LEXINGTON-FAYETTE URBAN COUNTY GOVERNMENT CONTRACT CHANGE ORDER Page 1 of 2		Date:	January 12, 2017
		Project:	Fire Station #2 Replacement
		Location:	Lexington
To (Contractor): Olympic Construction, LLC 216 Bromme Drive Nicholasville, KY 40356	Contract No.	013-2016	
	Original Contract Amt.	\$4,618,900.00	
	Cumulative Amount of Previous Change Orders	\$11,907.20	
	Percent Change - Previous Change Orders	0.26%	
	Total Contract Amount Prior to this Change Order	\$4,630,807.20	
	Change Order No.	6	
	You are hereby requested to comply with the following changes from the contract plans and specification;		
Current Change Order

JUSTIFICATION FOR CHANGE

PROJECT: Fire Station #2 Replacement

CHANGE ORDER NO. 6

TPC-1.1

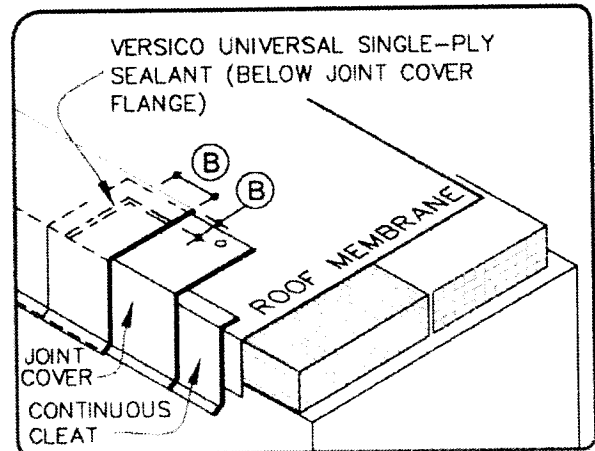
1. Necessity for change: Contractor made a recommendation for a better roof edge construction which maintains original warranty, unforeseen conditions were encountered when completing the storm sewer crossing, and roofing manufacturer never performed a mid-term roof inspection as required by the specification making a credit to the contract appropriate.

RFI #14 Coping Substitution Credit

REMARKS Lex Fire RFI #14 - Gravel Stop Parapet Detail

This letter is in regards to the roof edge termination on top of a parapet wall. It is acceptable to use a metal coping or a metal edge/drip edge on top of a parapet wall that is 31" wide for our standard 20-Yr Total System Warranty.
